April 9, 2015

Members, State Water Resources Control Board
Attn: Ms. Jeanine Townsend, Clerk to the Board
State Water Resources Control Board
1001 "I" Street, 24th Floor
Sacramento, CA 95814

Comment Letter – Desalination Amendment to California Ocean Plan

Figure 1
 Carlsbad Desalination Project
 Comparison of Maximum Daily Salinity to
 Average Salinity by Month (1980-2012)

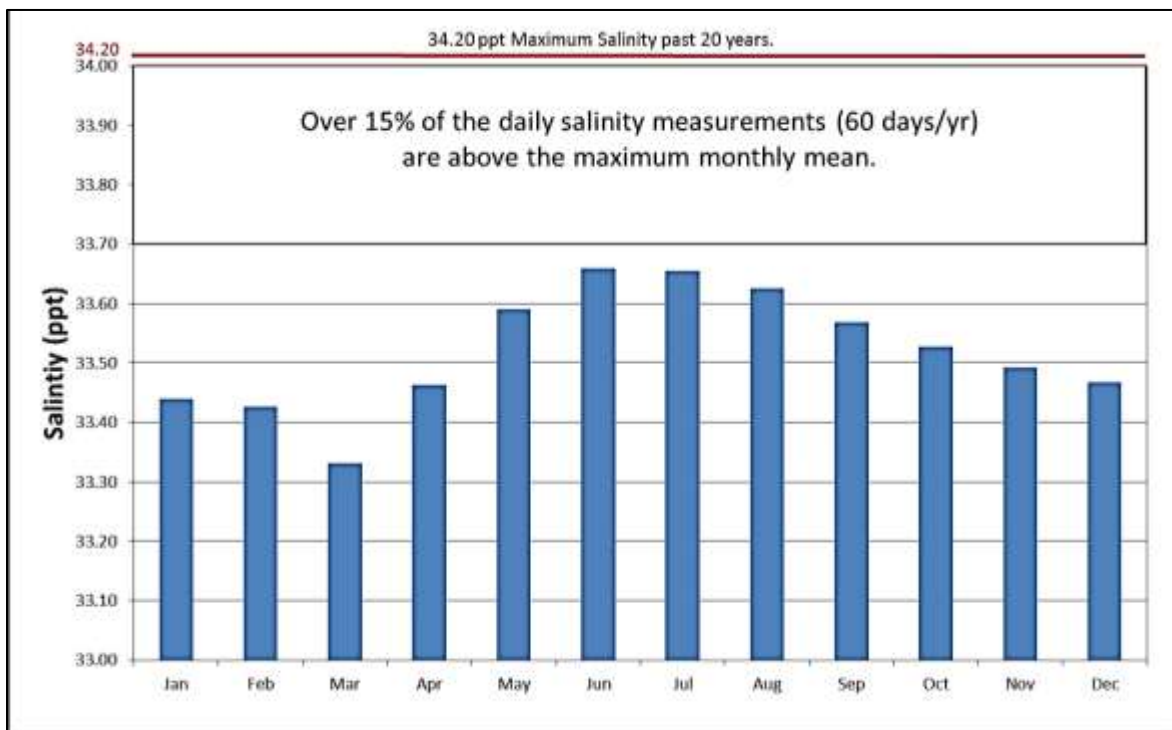
background salinity for the Carlsbad Desalination Project shows a mean salinity of 33.5 ppt, a minimum salinity of 27.4 ppt, and a maximum salinity of 34.2 ppt over the last 20 years. The monthly mean, on the other hand, has a much narrower range from a low of 33.4 to a high of 33.7. Sixty-four percent of daily salinity measurements over the last 20 years are above the annual mean monthly salinity, as shown in Figure 1, 15 percent of the daily salinity measurements are above the maximum monthly mean. Under the proposed requirements, the Carlsbad facility would have to operate with less than a 2 ppt increase over the ambient salinity more than 60 days per year, which would severely impact plant reliability.

To address this problem, Poseidon requests the Desalination Amendment be revised to provide that the “natural background salinity” at a given location is defined as the 20-year mean monthly salinity at the project location unless the actual salinity measured at the facility intake absent any influence from the discharge is greater than the 20 year mean monthly salinity, in which case, the natural background salinity shall be the actual salinity measured at the intake absent any influence from the discharge.

NATURAL BACKGROUND SALINITY is the salinity* at a location that results from naturally occurring processes and is without apparent human influence. For purposes of determining natural background salinity, the mean monthly natural salinity shall be used. Mean monthly nNatural background salinity shall be determined by averaging 20 years of historical salinity* data at a location in the proximity of the proposed discharge location unless the actual salinity measured at the facility intake, absent any influence from the discharge, is greater than the 20 year mean monthly natural salinity, in which case, the natural background salinity shall be the actual salinity measured at the intake absent any influence from the discharge and at the depth of the proposed discharge, when feasible.* For historical data not recorded in parts per thousand, the regional water boards may accept converted data at their discretion. When historical data are not available, natural background salinity shall be determined by measuring salinity* at depth of proposed discharge for three years, on a weekly basis prior to a desalination facility* discharging brine,* and the mean monthly natural averagesalinity* shall be used to determine natural background salinity unless the actual salinity measured at the facility intake, absent any influence from the discharge, is greater than the 20 year mean monthly natural salinity, in which case, the natural background salinity shall be the actual salinity measured at the intake absent any influence from the discharge. Facilities shall establish a reference location with similar natural background salinity to be used for comparison in ongoing monitoring of brine* discharges.
